ECE/TRANS/WP.29/GRE/2006/57
9 August 2006

PROPOSAL FOR DRAFT AMENDMENTS TO REGULATION No. 48

(Installation of lighting and light-signalling devices)

Submitted by the expert from Japan

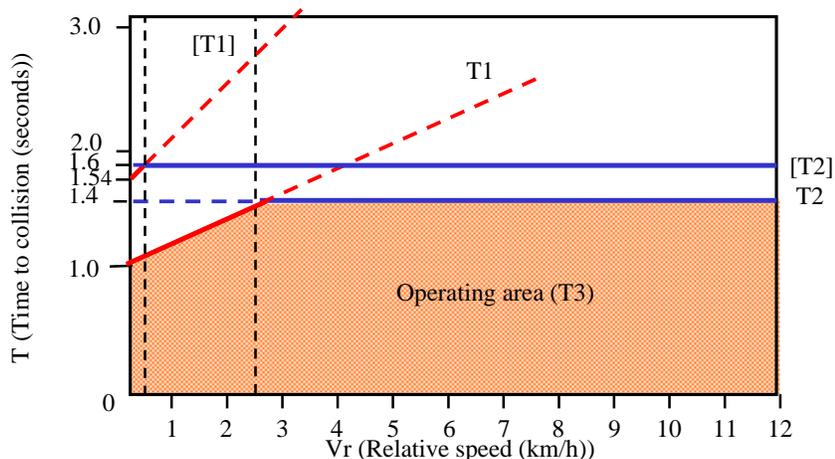
"6.6.7.3. The signal may be activated automatically in case the collision seems to happen. This shall be deemed to be satisfied if the following conditions are met:

6.6.7.3.1. where the estimated time to collision (T) which is the time obtained by dividing distance by relative speed between following vehicle and leading vehicle, is not more than T1 (braking avoidance timing) and T2 (steering avoidance timing) (see figure below);

$T1 = 0.0167 V_r + 1.00$ (if $0 < V_r < 24.0$) or

$[T1 = 0.0317 V_r + 1.54$ (if $0 < V_r < 1.9$)]

and $T2 = 1.4$ (if $V_r \geq 24.0$) or $[T2 = 1.6$ (if $V_r \geq 1.9$)]

Distribution of brake start timing in normal avoidance:
(Example of small-sized motor vehicles)

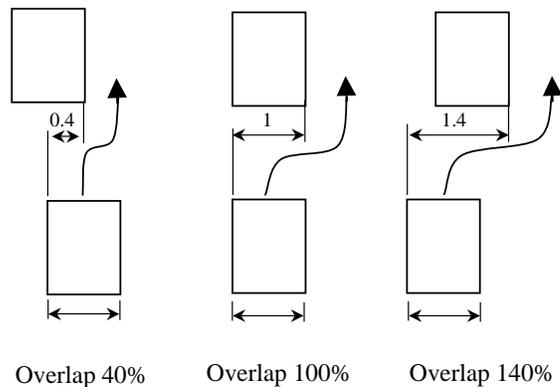
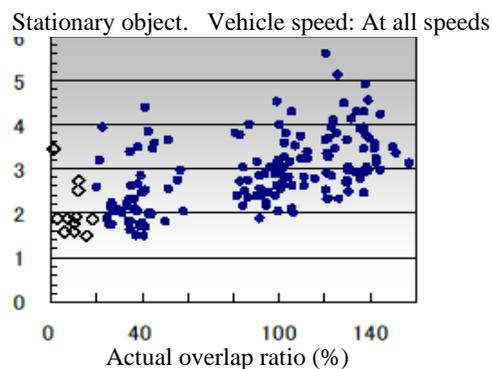
These values can be expressed by a linear formula " $T1=0.0167Vr + 1.00$ " in the case of small-sized motor vehicles; and " $T1=0.0317Vr + 1.54$ " in the case of large-sized motor vehicles.

Moreover, this means that, as an example, when a motor vehicle running at a speed of 30 km/h is getting closer to another stationary motor vehicle, the driver starts braking avoidance at a deceleration equivalent to 0.6 G + a marginal vehicle-to-vehicle distance of approximately 6.6 m in the case of small-sized motor vehicles; and at a deceleration equivalent to 0.6 G + a marginal vehicle-to-vehicle distance of 15.0 m in the case of large-sized motor vehicles.

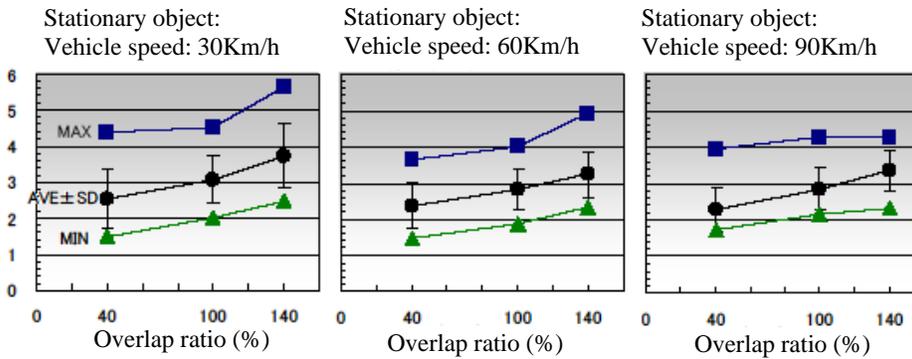
Minimum values:

Small-sized motor vehicles: 1.47 (seconds);

Large-sized motor vehicles: 1.64 (seconds).

Note: These values do not vary greatly depending of the vehicle speed.

The minimum value of these values (the minimum value of the steering start timing) is regarded as the threshold value.
